Summary of Items Discussed in 5/2014 APSEC Discussion Forum on 10 November 2014

14. Temporary Refuge Spaces (TRS) and Wider Corridor / Lobby

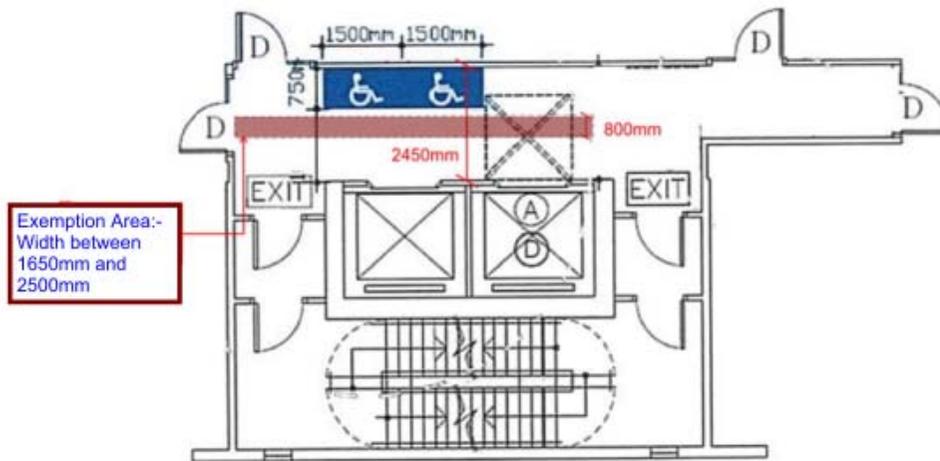
FS Code Section 4 Clause B30 – Addenda and Consequential Corrigenda to the FS Code for the Provisions of Means of Escape for Persons with a Disability in Case of Fire and JPN1 refer. Please kindly clarify the followings:-

- If TRS (emergency use only) are provided within the Fireman's Lift Lobby (naturally ventilated) of Typical Residential Floors, please clarify which calculation for widen lift lobbies exemption shall be used as per below diagrams:

Scenario 1

Exemption portion in front of TRS

= Overall width (2450mm) - 1650mm

= 800mm

The BD confirmed that **Scenario 3** should be adopted in calculating the exempted GFA for the provision of a wider common corridor / lobby under JPN 1.

<p>Scenario 3 Exemption portion in front of TRS = Overall width (2450mm) - TRS (750mm) - width for required exit route (1050mm) = 650mm</p>	
15.	<p><u>Storey Height above Transfer Plate</u></p> <p>For residential developments, there is a general practice of an E&M zone above the transfer plate allowing flexibility in diversion of pipe works through transfer plate openings. Please clarify that this E&M zone does not account for the total floor-to-floor height of storey above transfer plate. The floor-to-floor height of storey above transfer plate should be accounted from the top of this E&M zone to the structural floor level of floor above.</p>	<p>The BD confirmed that the depth of E&M zone above the structural transfer plate should NOT be included in the floor to floor height of the storey above the transfer plate for the purpose of regulation 23(3)(a) of the B(P)R.</p>
